Reference: CHEO Integrated Treatment Centre, 401 Smyth Road
Response to March 19th and February 18th Traffic Comments
Novatech File No. 122210

Please see the following responses to the municipality's traffic related 1st Review comments dated March 19, 2025 and February 18, 2025, regarding the Site Plan application for the new 'Integrated Treatment Centre' building within the campus of the Children's Hospital of Eastern Ontario (CHEO).

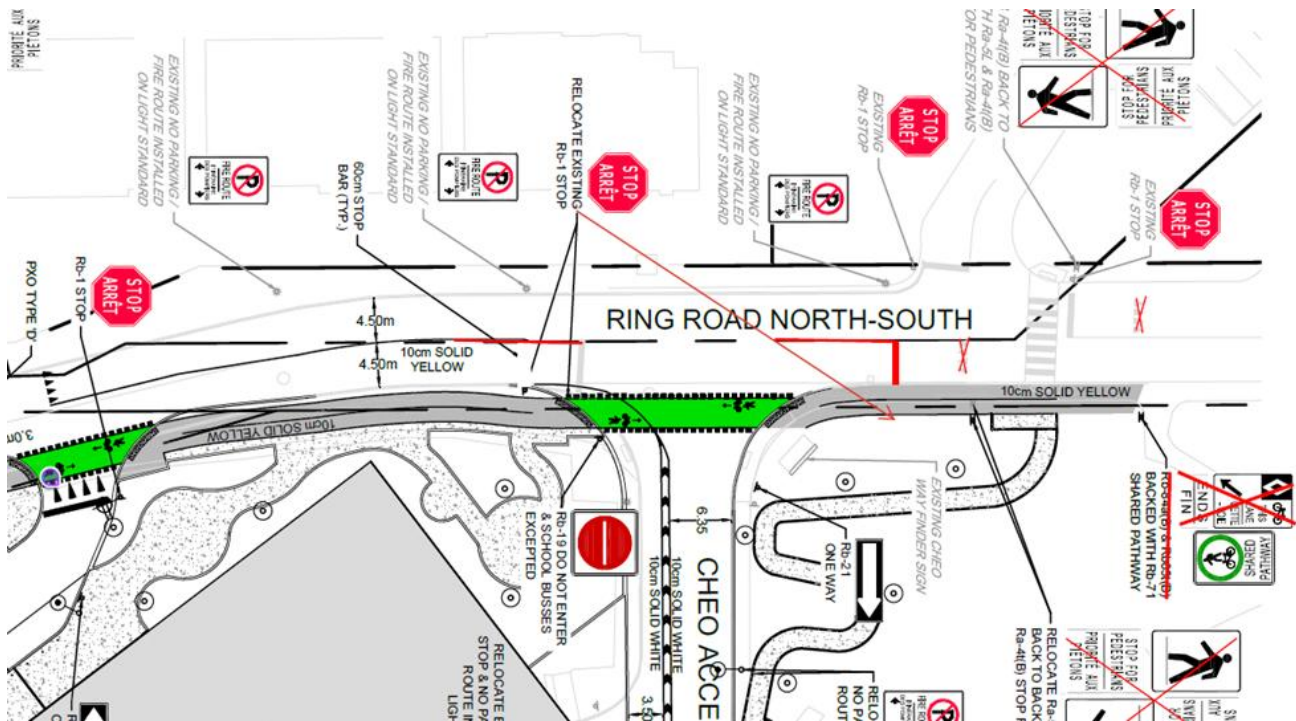
With the change to the CHEO Non-Emergency Access to be one-way, consider relocating the northbound stop bar / stop sign on Ring Road (N-S) northwards to the 'Rotel' access to normalize the all-way stop control. Relocate the northbound Wb-1 Stop Ahead sign to match. Also recommend removing the redundant PXO pavement marking and signage at this all way stop control. Finally, remove the proposed Rb-84a and Rb85t signage. Refer to markup below:

Response: This has been updated per the markup.

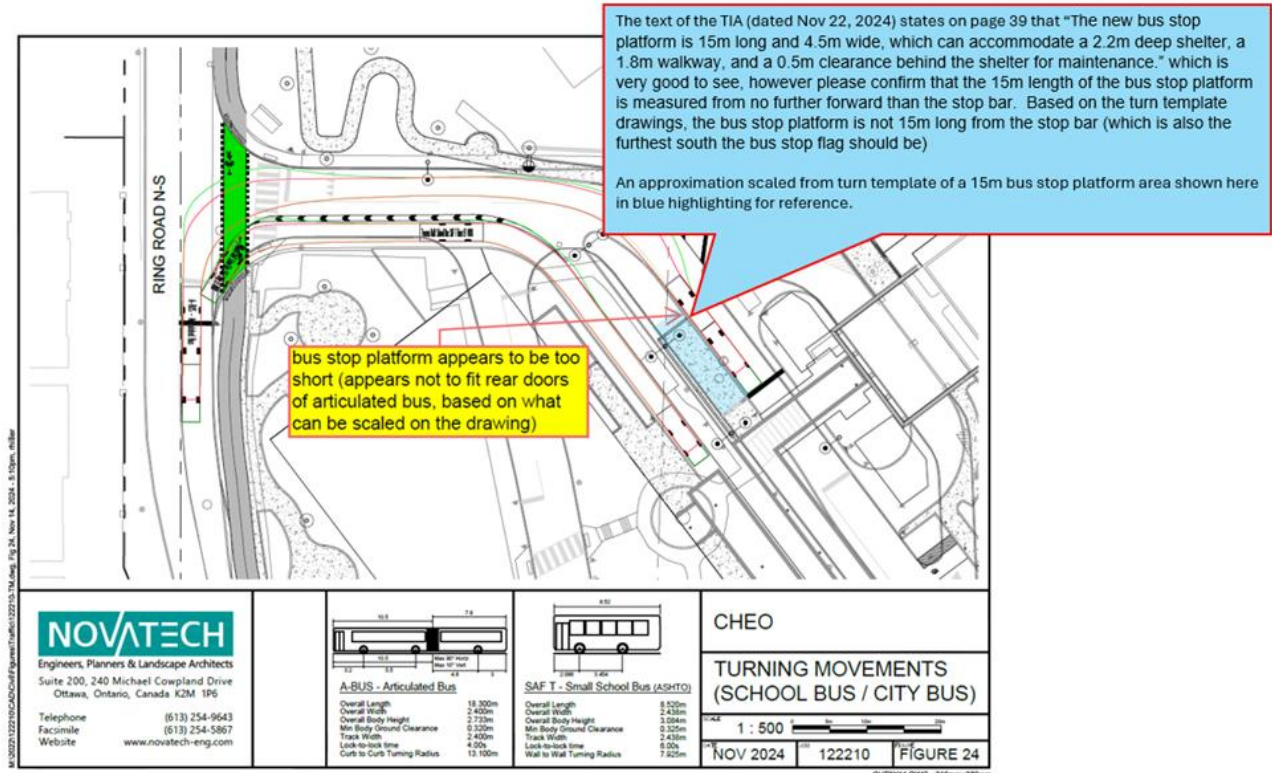
However, the drawings included with this TIA circulation were inconsistent with each other, and clarification is needed. The turn template drawings show a platform area which scales smaller than the 15m length needed, and the Site Plan in the TIA shows a length of 14.9m (unclear if that is from the stop bar or not). An approximation shown here in blue highlighting of a 15m bus stop platform area for reference.

Please confirm that the 15m length of the bus stop platform is measured from no further forward / south than the stop bar.

Response: The 15m bus stop platform has been provided, and the stop bar has been relocated so that the bus stop platform begins at the stop bar. This is shown in the revised Pavement Markings and Signage Drawings.

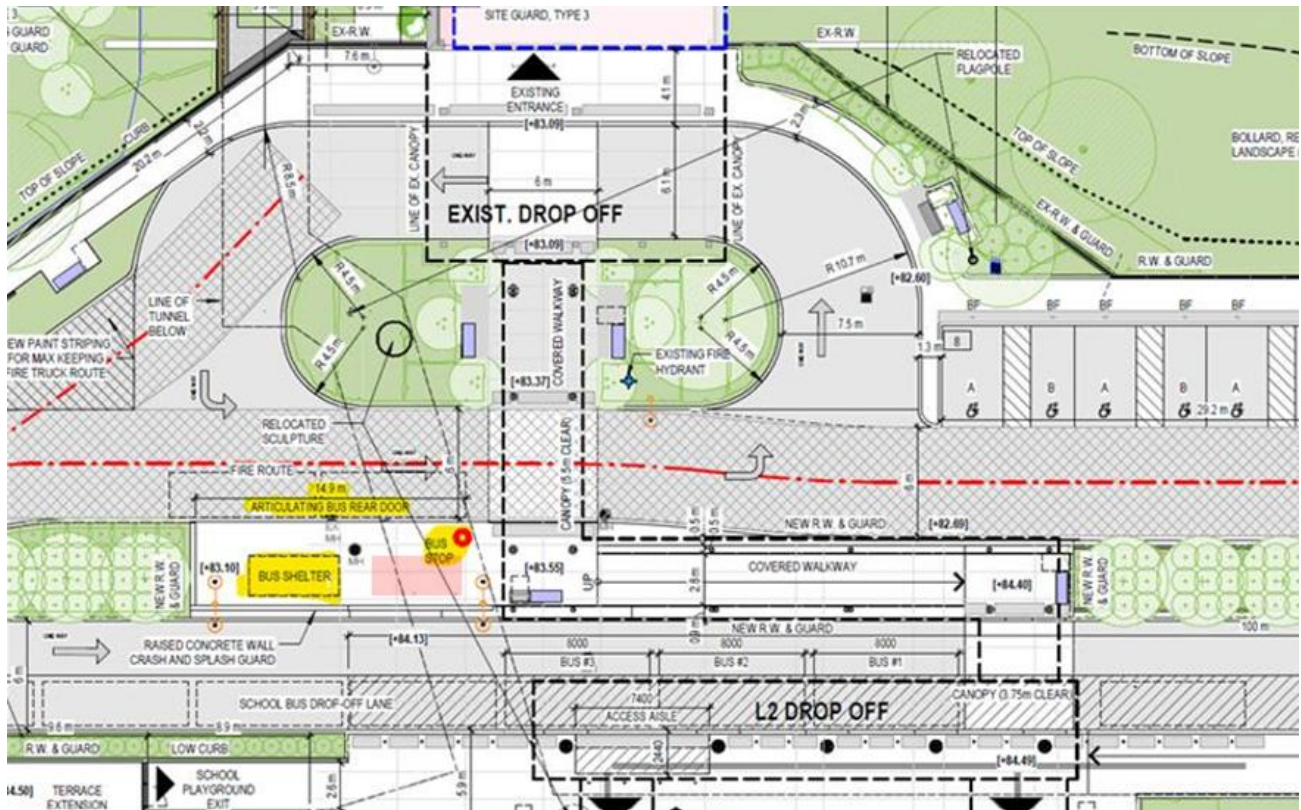
The bus stop shelter is shown in the TIA Site Plan is shown positioned further away from the bus stop flag (at the stop bar) than would be typical. Can the shelter be positioned closer to the bus stop sign in order to minimize walking distance for customers waiting for the bus? Although there is a planned maintenance hole (MH) within the bus stop platform area, it would appear that the bus stop shelter footprint on the site plan could be adjusted to the south (closer to the crosswalk) without impacting the MH. Mock-up in red highlighting below.

Response: The bus shelter has been relocated and placed as close as possible to the bus stop flag.

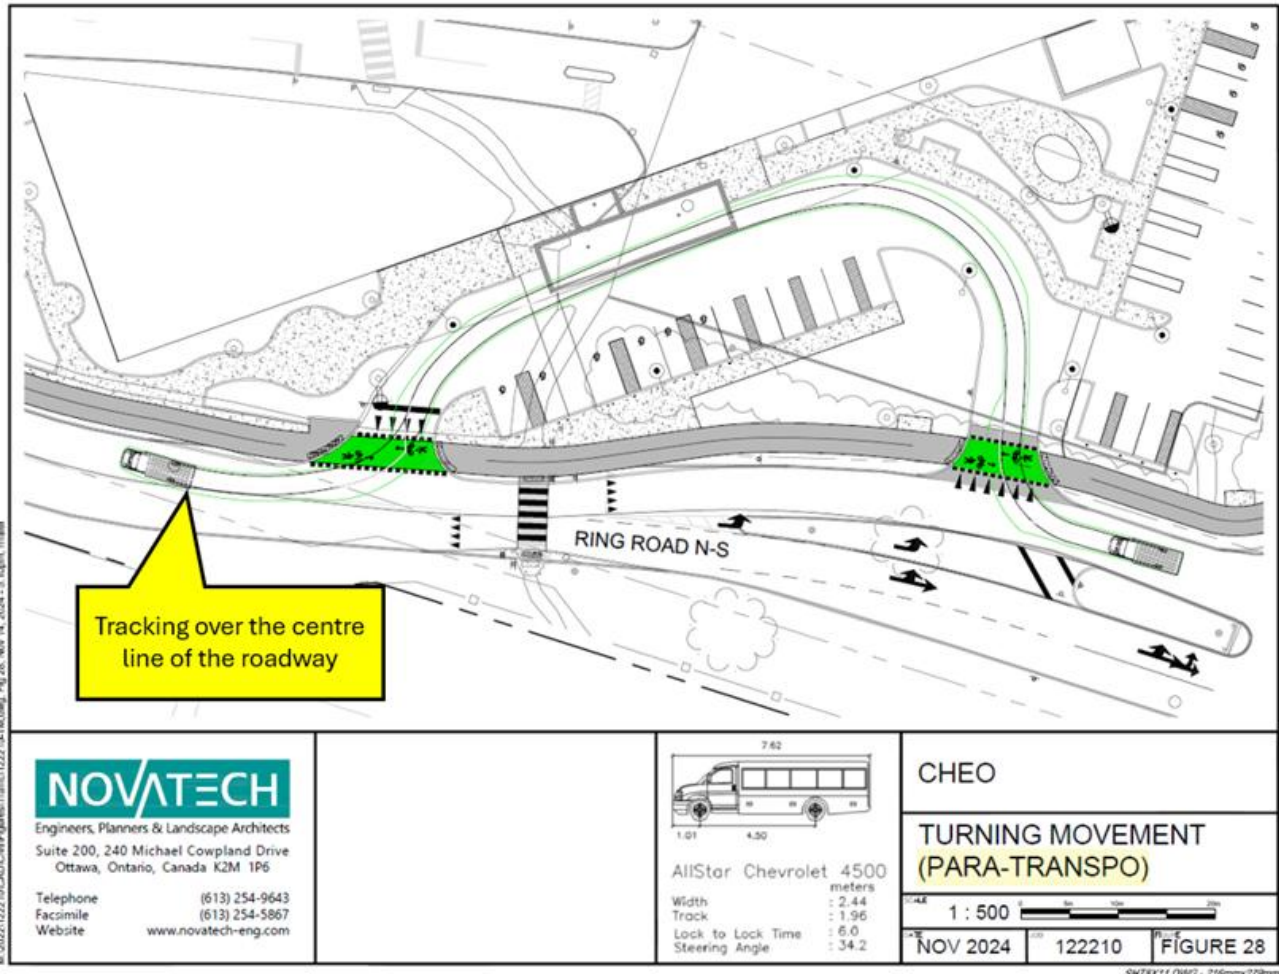
Also noted with the turning templates, there are still a few places where the bus is tracking outside of its lane:

- *The conventional buses are tracking over the accessible parking spaces along the CHEO driveway*

- The Para Transpo bus is shown tracking over the centre line of the Ring Road (N-S)

Response: Updated turning movements have been provided in the updated TIA report.

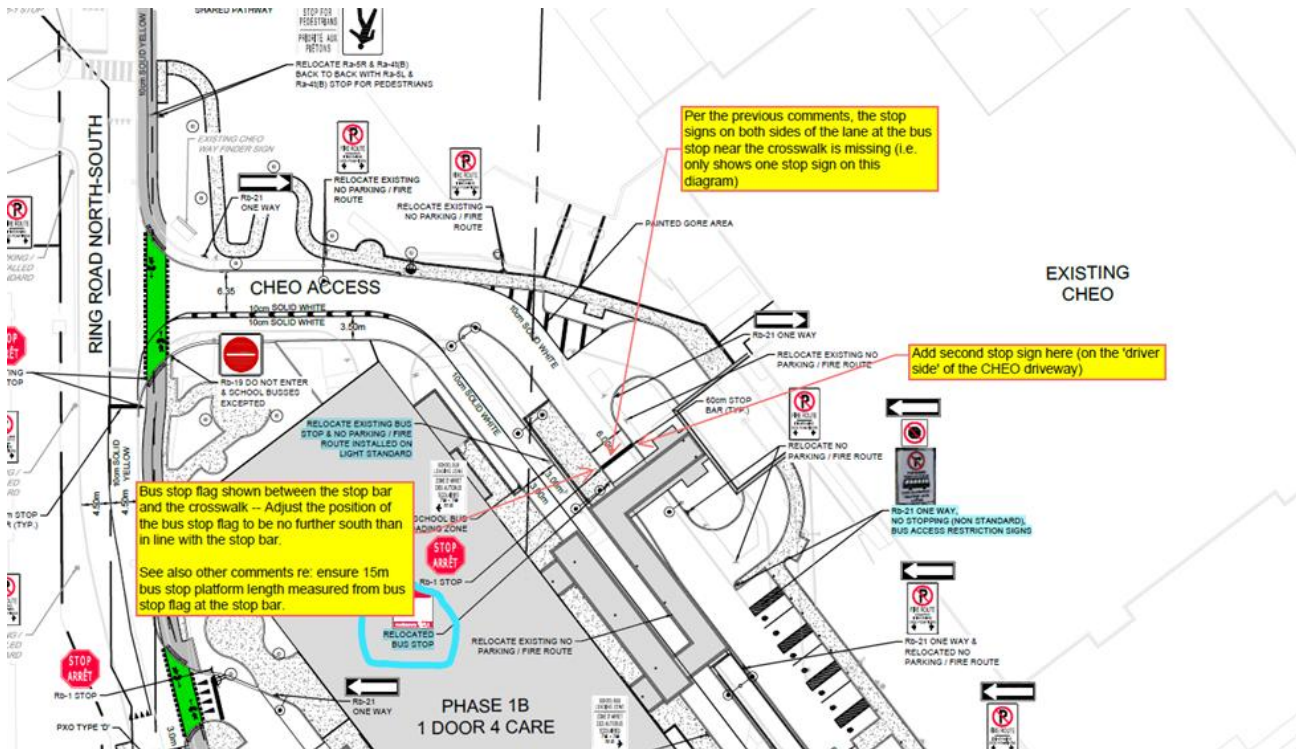
In the Proposed Pavement and Markings drawing the requested second stop sign is missing. Add the requested second stop sign to have stop signs on both sides of the CHEO driveway roadway at the stop bar before the cross walk (one on driver side, one on passenger side). The goal for the dual stop signs is to ensure that no vehicles try to pass any vehicle, but in particular a stopped transit bus, near the crosswalk.

Response: Stop signs have been provided on both sides of the CHEO driveway roadway at the stop bar in the revised Pavement Marking and Signage drawings.

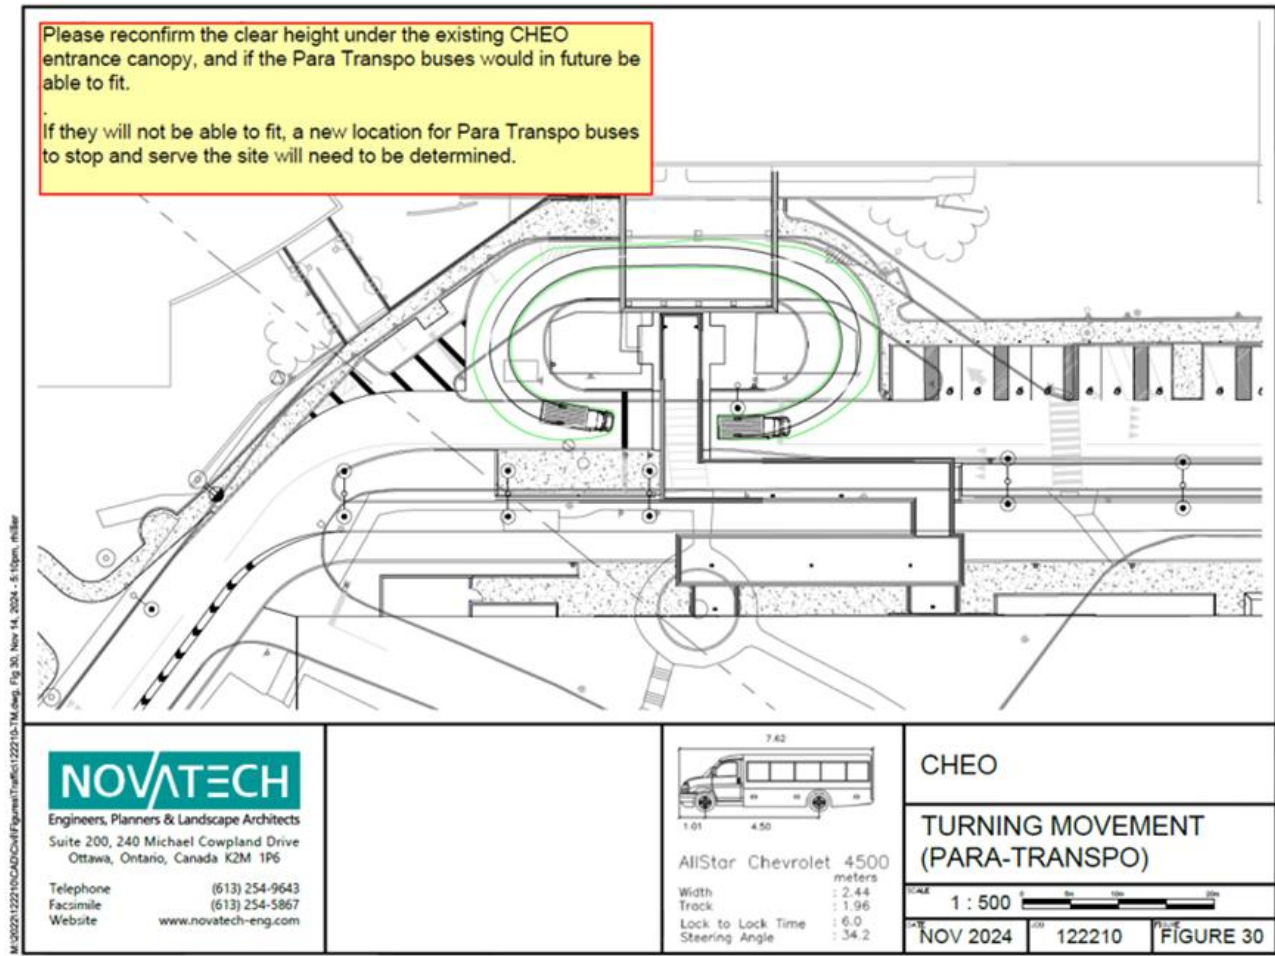
- As a part of conversations with the constructor during the current tunnel construction works, it was confirmed that the existing CHEO canopy is not tall enough to accommodate the Para Transpo buses. Subsequent to this we were also able to get internal clarification that there is one named stop for Para at CHEO, but functionally it is two stops – with the Para buses (prior to construction detour) staying on the driveway northbound and stopping near / at the stop sign before the conventional bus stop, and for the contracted taxis and vans for Para Transpo being shorter in height were able to use the area under the existing CHEO canopy.

- Please reconfirm the clear height under the existing CHEO entrance canopy, and if the Para Transpo buses would in future be able to fit. If they will not be able to fit, a new location for Para Transpo buses to stop and serve the site will need to be determined.

With current information we likely need to determine a secondary Para Transpo stop location for use of our Para Transpo Buses (contracted taxi sedans and vans may still be able to use the existing CHEO canopy depending on the logistics of the stop for the Para Transpo buses). This secondary Para Transpo stop may impact overall operations for transit and for the hospital traffic flow, so we would like to discuss this soon.

Response: As the canopy will not be altered as part of this development it is agreed that the Para Transpo stop needs to be relocated. The Para Transpo stop will be re-located. As shown in the updated drawings the Para Transpo stop will be relocated to the accessibility parking spots east of the drop-off loop.
